**THE LEGISLATIVE ASSEMBLY FOR THE
AUSTRALIAN CAPITAL TERRITORY**

**GOVERNMENT RESPONSE TO THE STANDING COMMITTEE ON PLANNING
AND URBAN RENEWAL REPORT 13 –
DRAFT VARIATION NO. 363 – CURTIN GROUP CENTRE AND ADJACENT
RESIDENTIAL AREAS: ZONE CHANGES AND AMENDMENTS TO THE
CURTIN PRECINCT MAP AND CODE**

**Presented by
Mick Gentleman MLA
Minister for Planning and Land Management**

Figure 3 Proposed zone changes

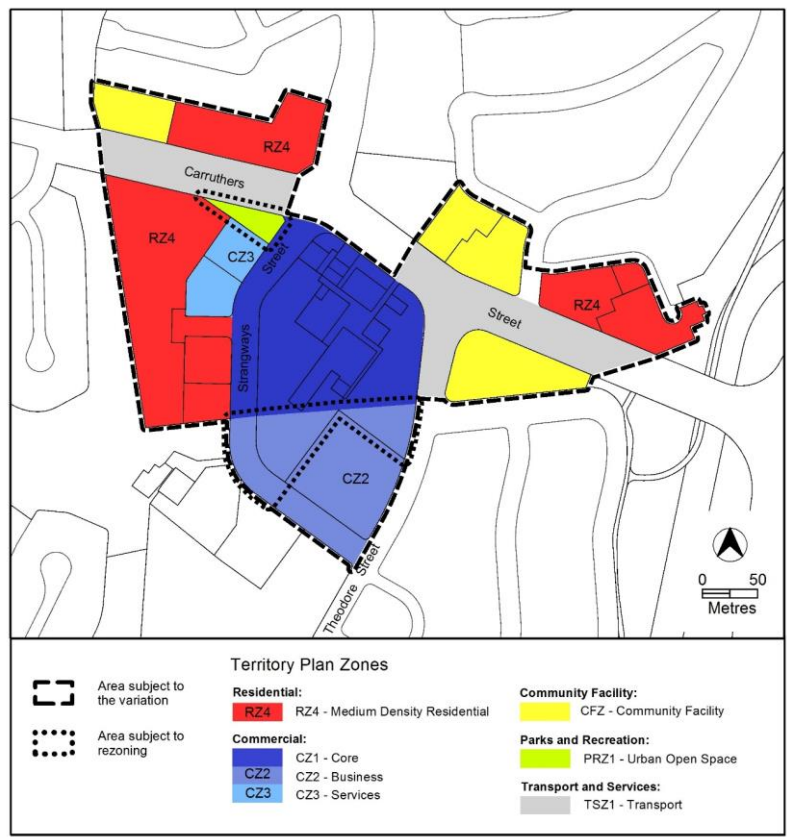
DV363 proposes to rezone section 63 block 7 Curtin from Commercial CZ3 Services zone and Residential RZ4 Medium Density zone to Parks and Recreation PRZ1 Urban Open Space zone to retain an important pedestrian route and form part of the wider open space network (refer Figures 2 & 3).

DV363 also proposes to rezone section 62 block 27 Curtin, which is the southern part of the centre, from the current Commercial CZ1 Core zone to CZ2 Business zone to focus the retail and community activity close to the central courtyard (refer Figures 2 & 3).

Figure 3 shows the zone changes proposed for the area subject to DV363.
